66311B-05

S E R V I C E N O T E

66311B

Reliability Improvement of Instrument

CORRECT J207 PLACEMENT – alignment to within $< 0.3\text{mm}$

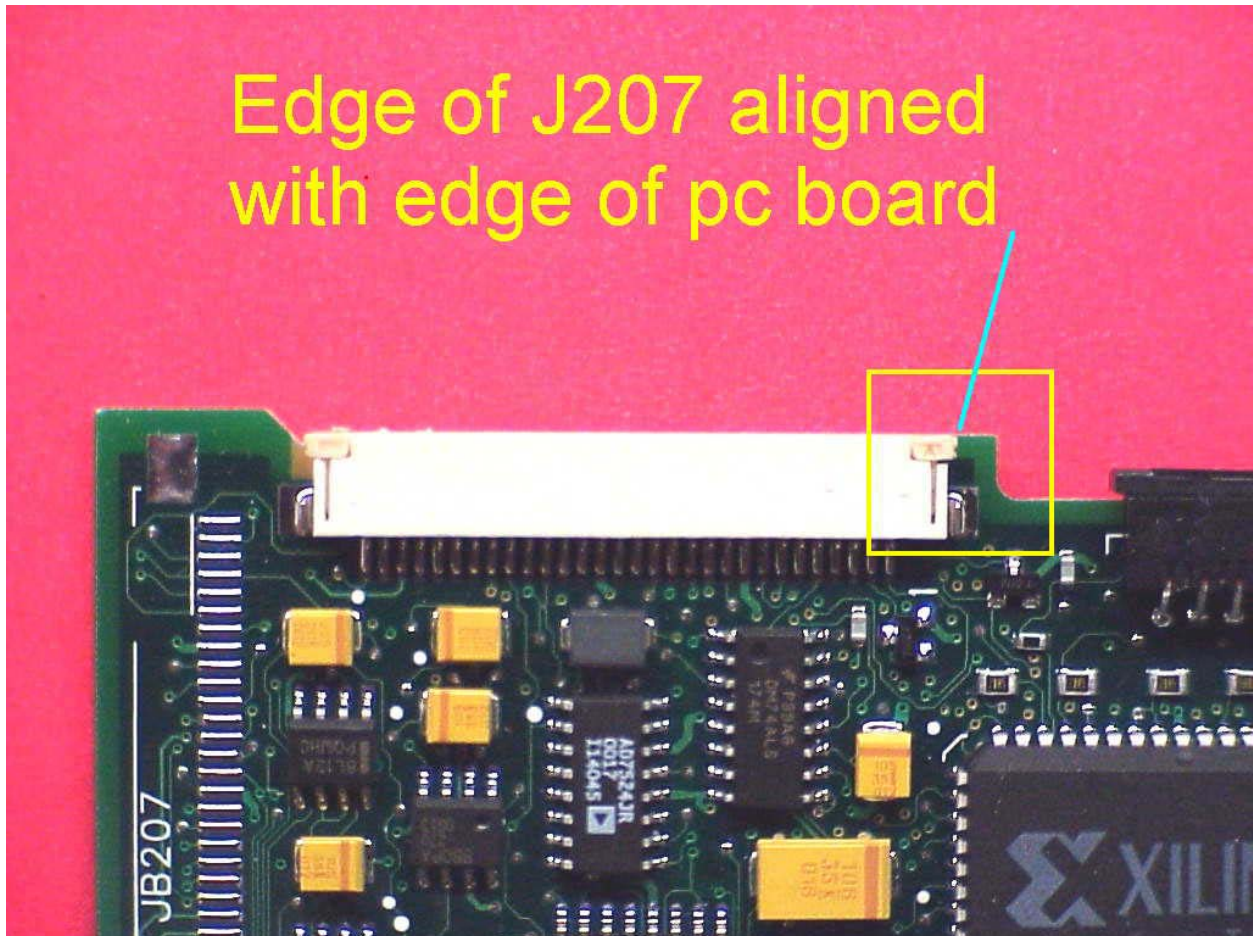
Latent product failure due to misplaced connector J207 on SMT assembly 5064-0018 (GPIB/RS232 interface). Misplacement of J207 could lead to inadvertent contact/shorting of exposed feed-throughs on SMT board. Ultimately, resulting in over-stress of components of damage to SMT board components. Resulting contact could degrade useful life of instrument.

Picture shows connector aligned to edge of SMT board to within $< 0.1\text{mm}$

- 1) Compare placement of J207 to attached photos. Instruments with a “misplaced” J207 should be returned to Agilent for warranty repair.
- 2) Instruments returned to the Service Center for routine calibration should be inspected for this potential defect. Defects should be addressed using Agilent’s unit exchange process with costs being charged to warranty.
- 3) The factory has modified production documentation to include visual inspection and specific electrical testing for this potential short.
- 4) Factory is maintaining feedback to SMT board supplier regarding quality of assembly.

INCORRECT J207 PLACEMENT – misaligned by $> 0.3\text{mm}$

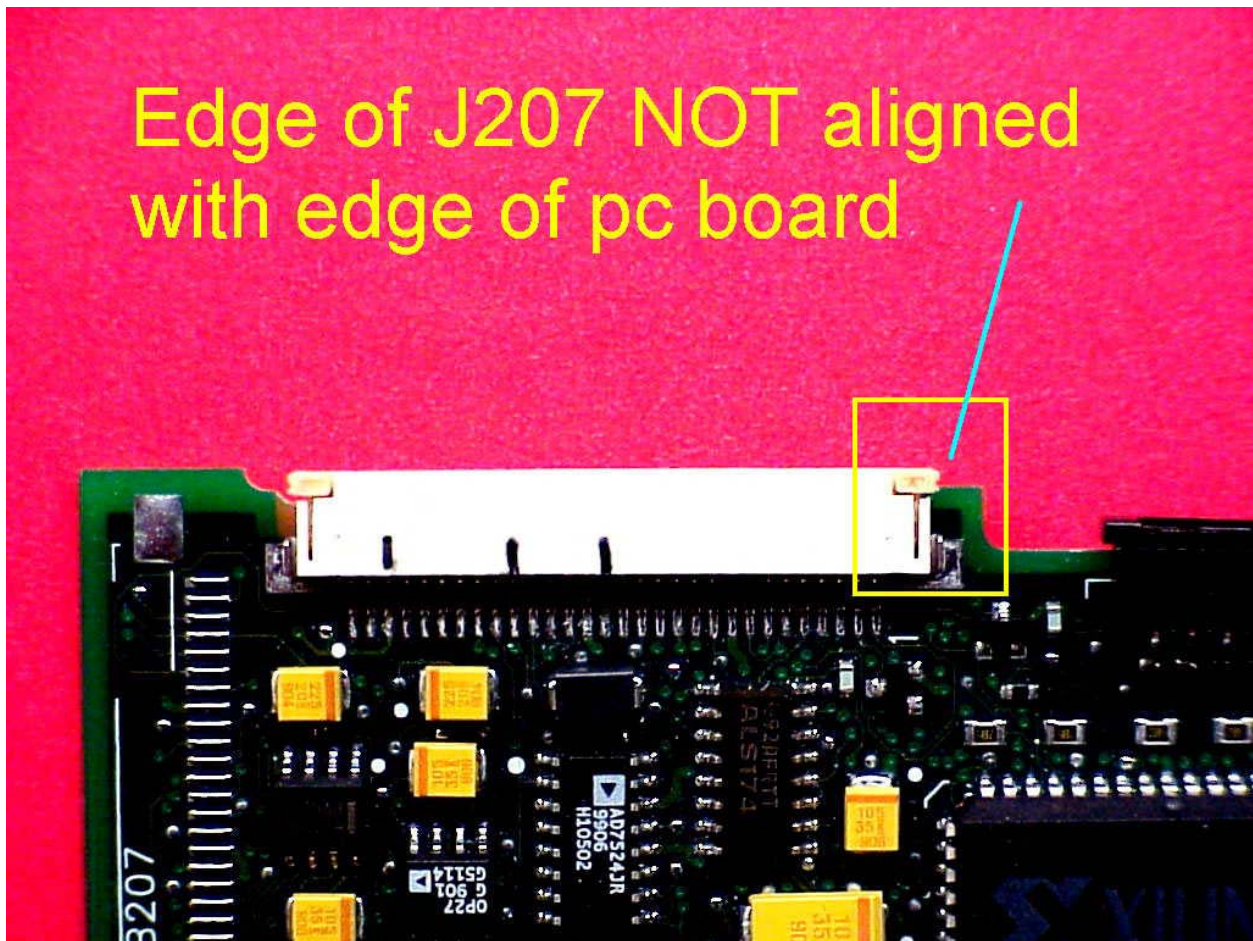
Picture shows connector extending past edge of SMT board by $>1.2\text{mm}$
